## COMMENTS

### II. Objection to Drawings

Applicant : David B. Miller  
Serial No. : 09/688,064  
Filed : October 13, 2000  
Page : 10

Attorney's Docket No.: 10001197-1

FIG. 6A

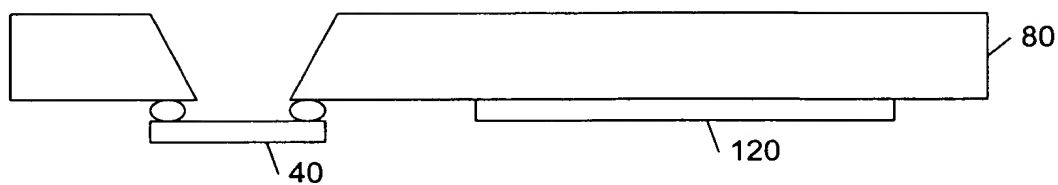
FIG. 6A has been amended in response to the Examiner's objection under 37 CFR 1.83(a). In particular, FIG. 6A has been amended to show diagrammatically that the integrated circuit 120 is formed on spacer substrate 80.
